STAFF REPORT

SUBJECT: FP-2020-0014
Stapleton No. 2

Final Plat consisting of 63 buildable lots and 8 common lots on 10.6 acres of land in the R-15 zoning district.

B. Final Plat (date: 1/5/2021)

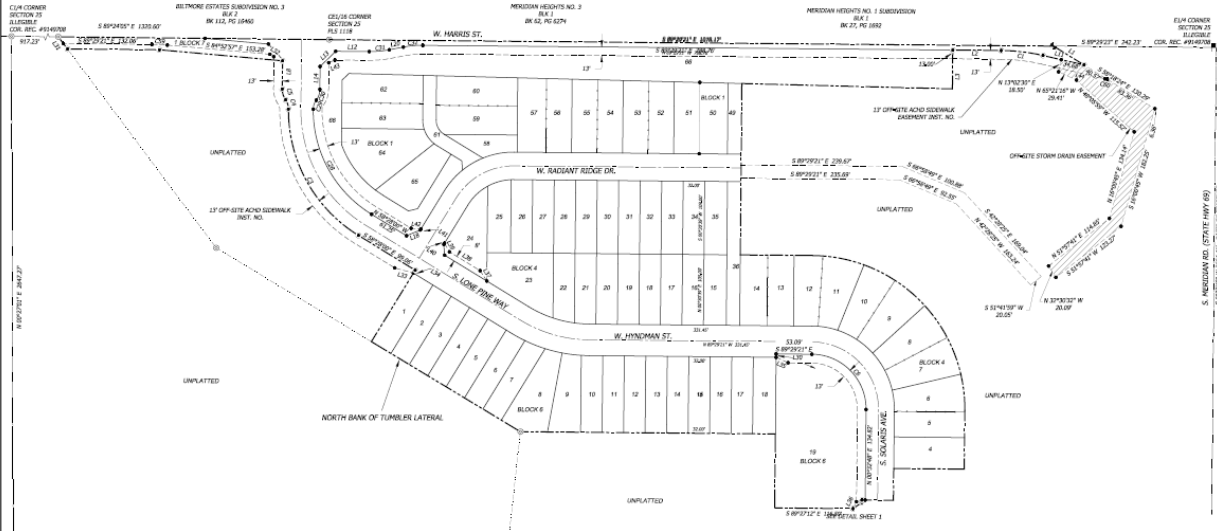
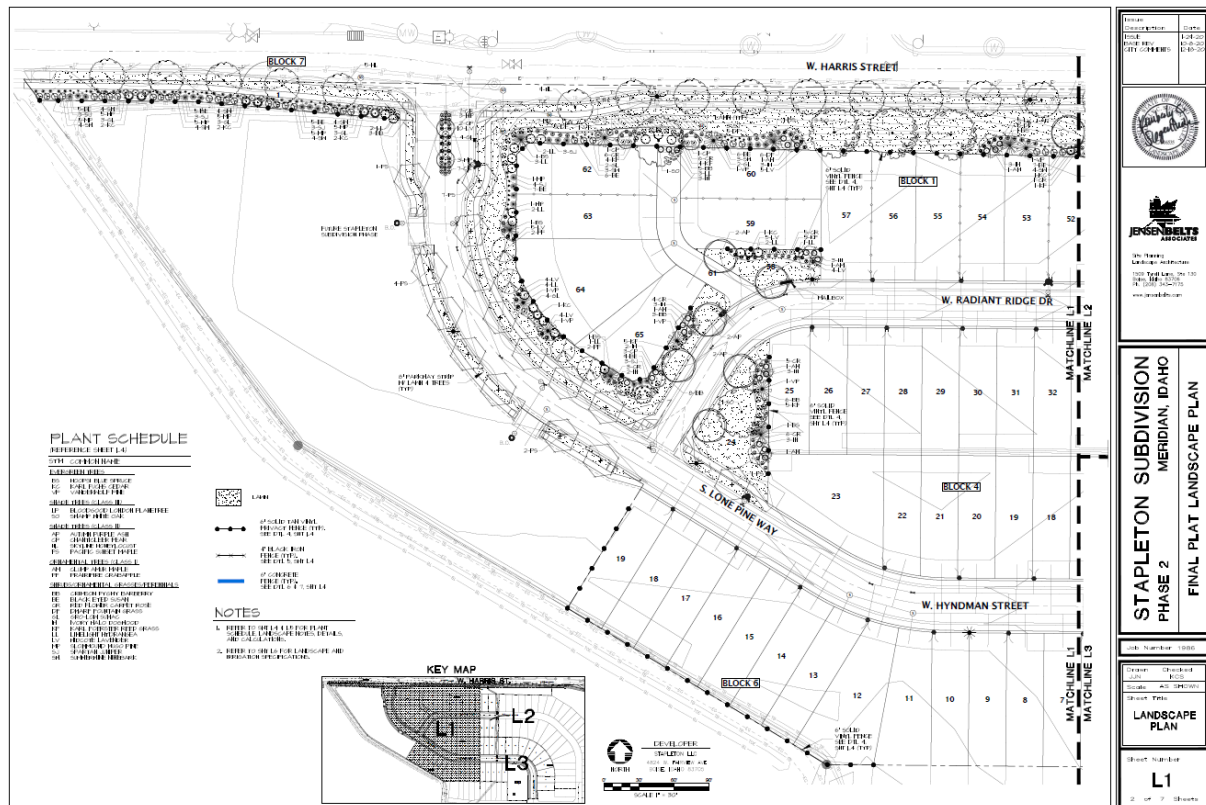
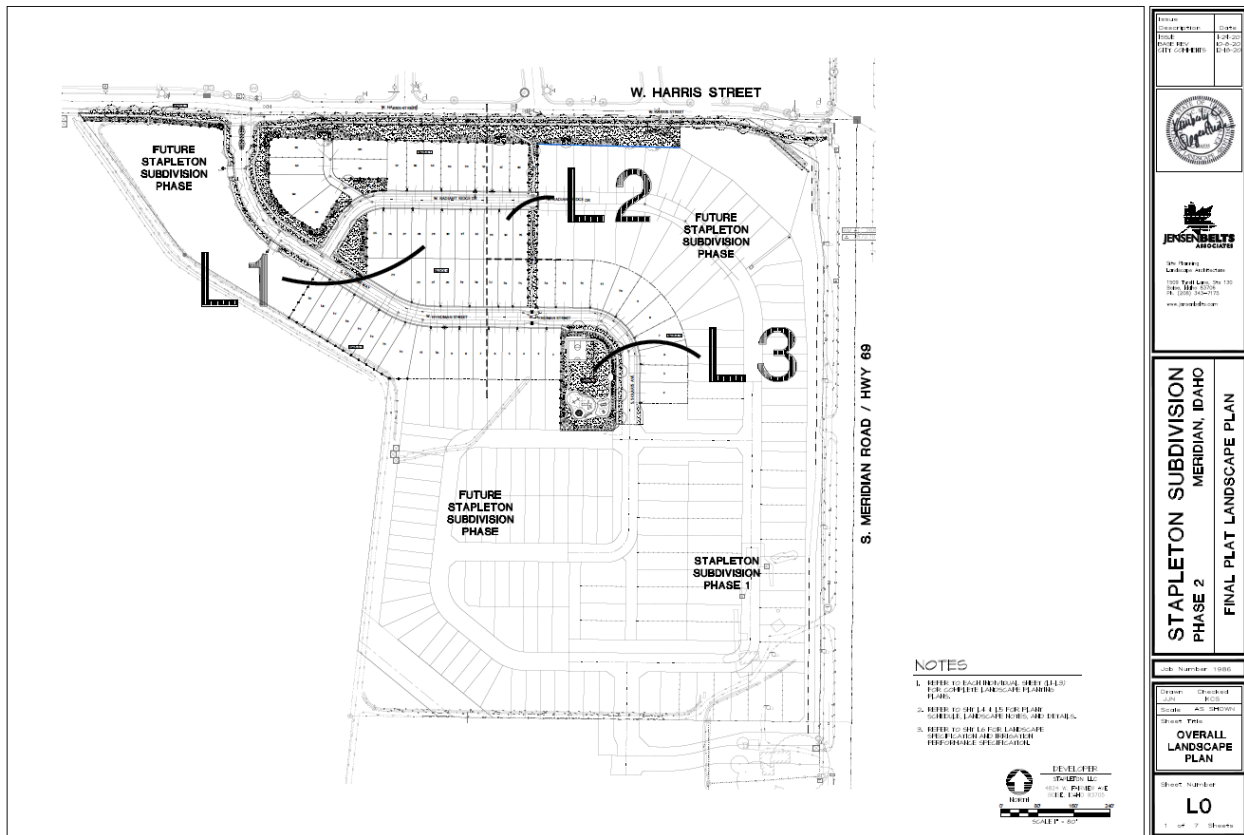
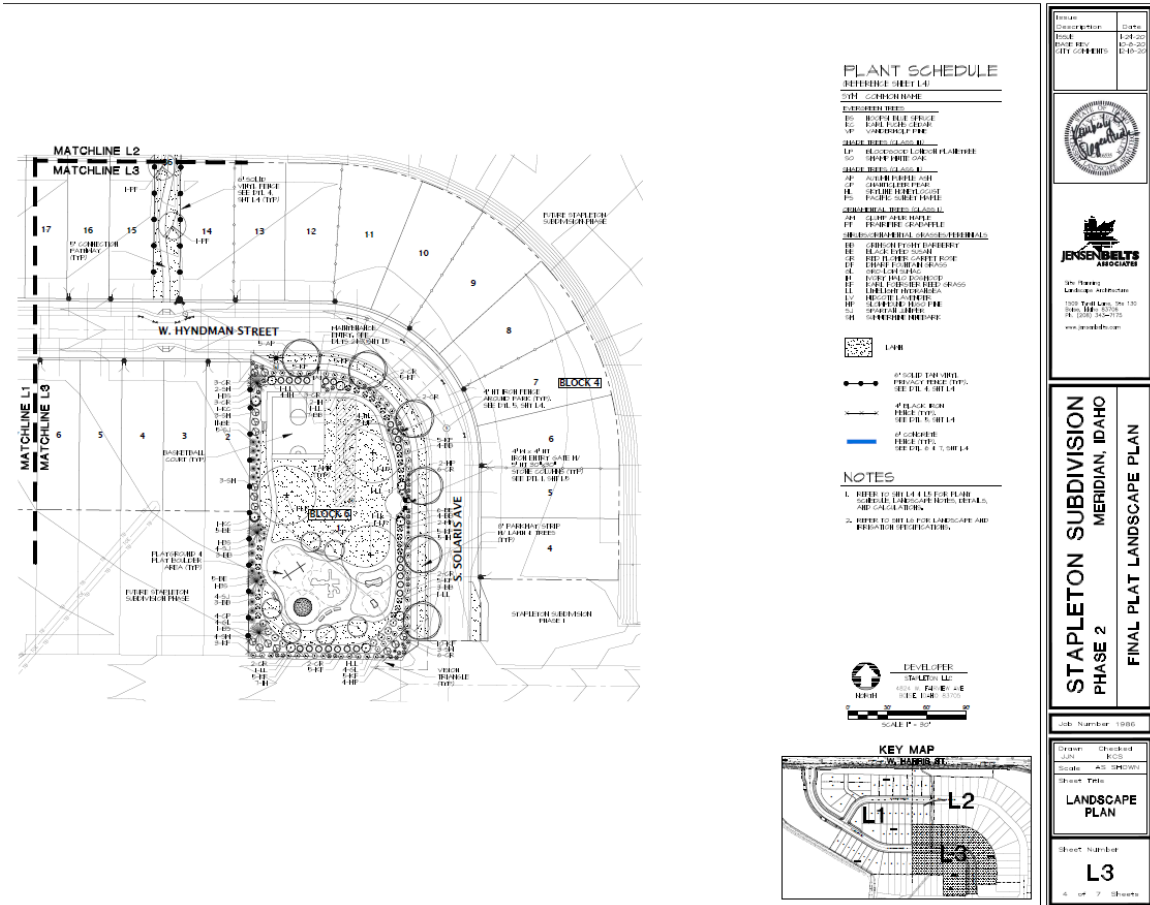
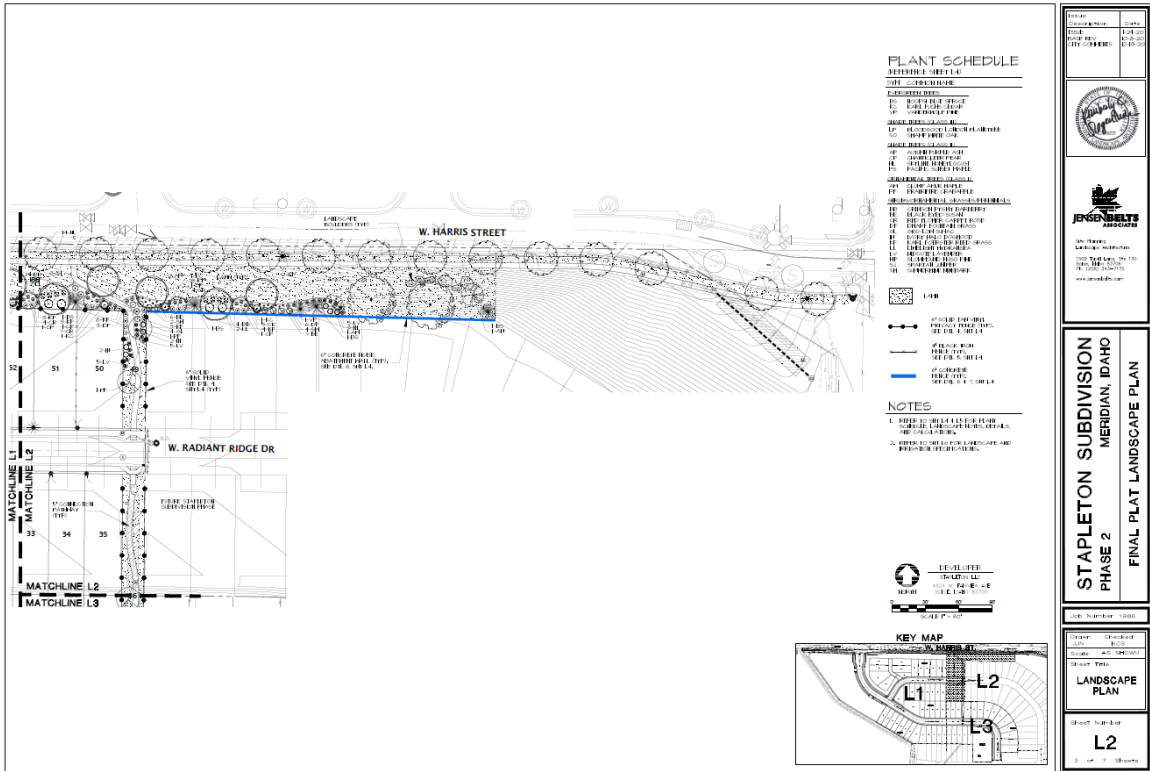
1. Applicant shall comply with all previous conditions of approval associated with this development (H-2018-0129, Development Agreement #2019-110907).
2. **The applicant shall obtain the City Engineer's signature on the subject final plat within two years of the City Engineer's signature on the previous phase final plat; or apply for a time extension, in accord with UDC 11-6B-7.**
3. Prior to submittal for the City Engineer's signature, have the Certificate of Owners and the accompanying acknowledgement signed and notarized.
4. The final plat prepared by Kevin M. Borah, Sawtooth Land Surveying, LLC, dated 1/5/2021, included in Section VII.B shall be revised as follows:

- a. Include the recorded instrument number for the ACHD sidewalk easement.
- b. Include the recorded instrument number for the ACHD storm drain easement.

- c. Note #5: Delete note; Homeowner's Associations are not governed by the City of Meridian.
- d. Note #6: ". . . Lot 19, Block 6, and Lot 1, Block 7 are reserved as common area. . ."
- e. Note #7: Include recorded instrument number for ACHD license agreement.
- f. Note #13: ". . . Lot 19, Block 6, are servient to and contain the ACHD storm water drainage system. . ."
- g. Note #14: Include recorded instrument number of ACHD sidewalk easement.
- h. Note #15: "The bottom of structural footing shall be set a minimum of 12-inches above the highest established normal ground water elevation."

- i. Depict the north/south shared lot line between Lots 50 and 51, Block 1 (Sheet 1).
 - j. Include the Surveyor's Narrative (Sheet 3).
 - k. Include the recorded instrument number for the ACHD sidewalk easement (Sheet 4).

C. Landscape Plan (dated: 12/18/20)

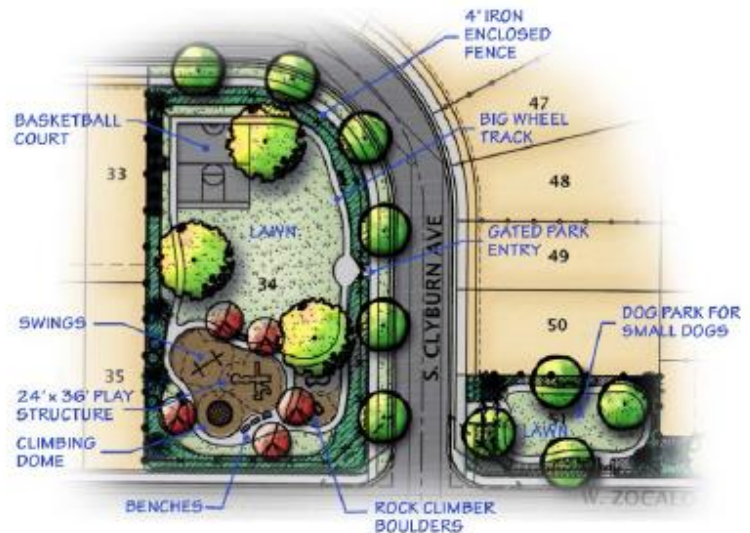
5. The landscape plan prepared by Jensen Belts Associates, dated 12/18/20, shall be revised as follows:
 - a. Re-number the lots consistent with the final plat.

- b. Include the total linear feet of parkways and the required number of trees in the Landscape Calculations table per the standards listed in UDC 11-3B-7C.3.
